GROUP	MODEL
ELE	2022-2024MY Soul (SK3)
NUMBER	DATE
402	November 2025

TECHNICAL SERVICE BULLETIN

SUBJECT: **POWER WINDOW MAIN SWITCH REPLACEMENT (CA2510)**

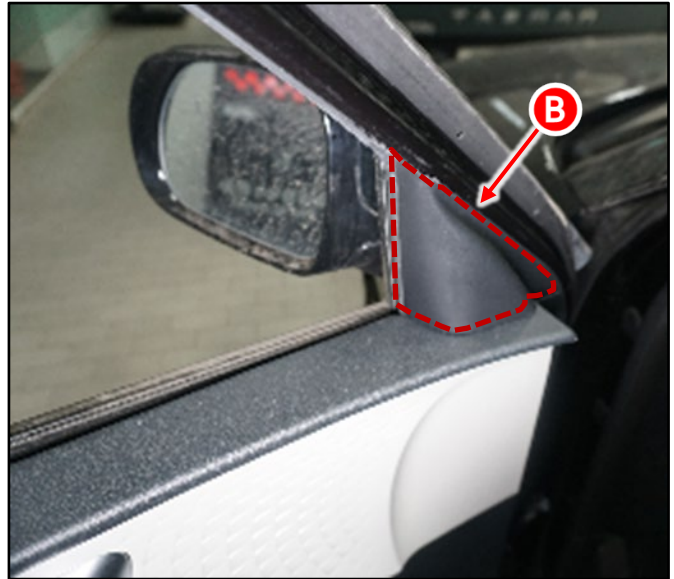
1. Disconnect the battery negative terminal after loosening nut (A).

2. Remove the front door quadrant inner cover (B).

3. Remove the front door pull handle mounting cap (C).

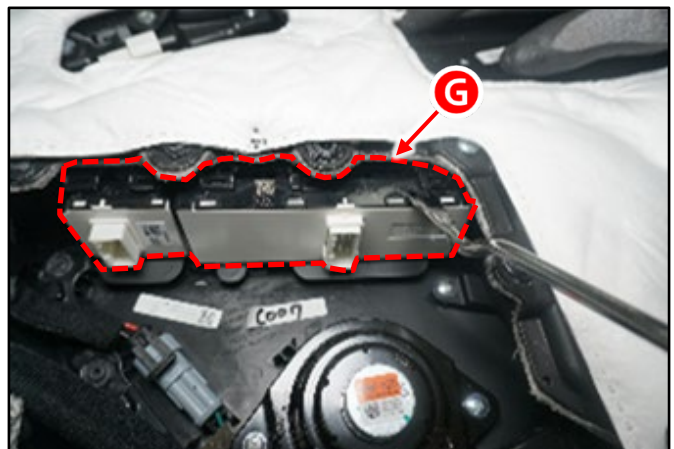
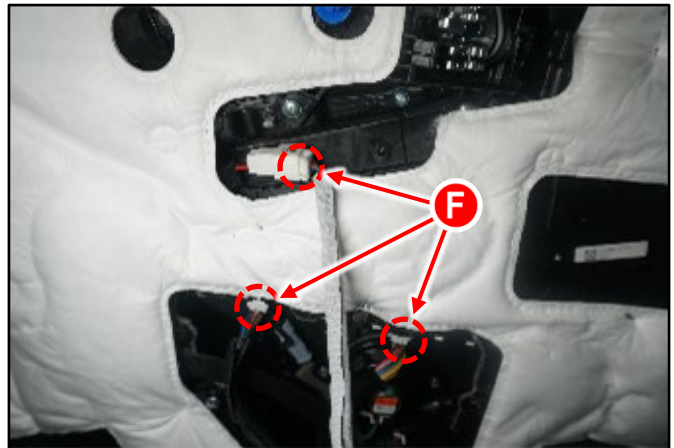
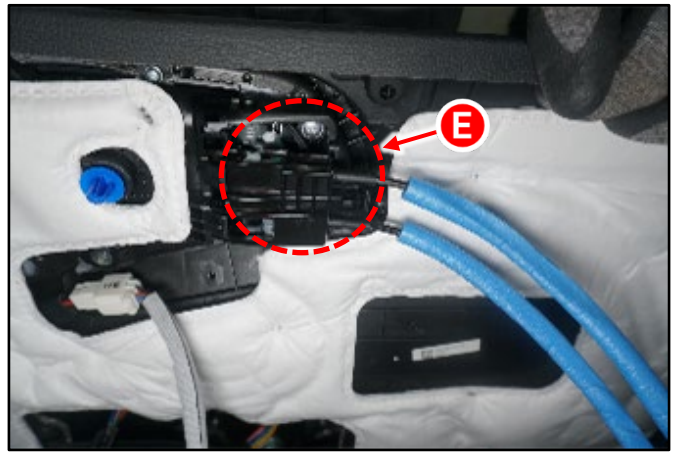
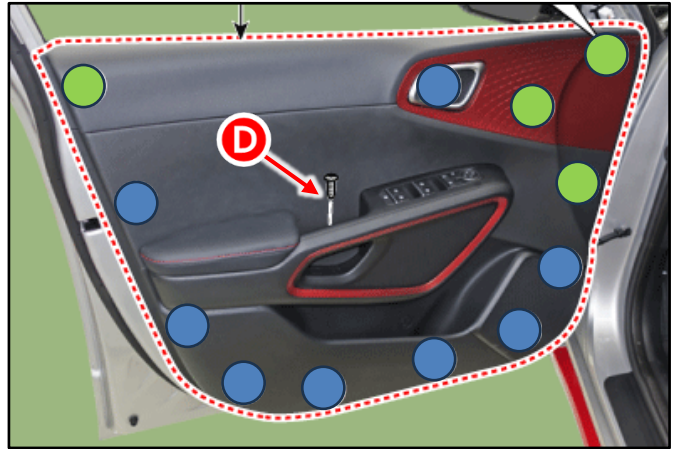
- Remove the driver's front door trim after loosening screw (D).

- Remove the door inside handle cable (E).

- Disconnect the front door trim connectors (F), 3EA.

- Remove the main power window switch and install the replacement switch.
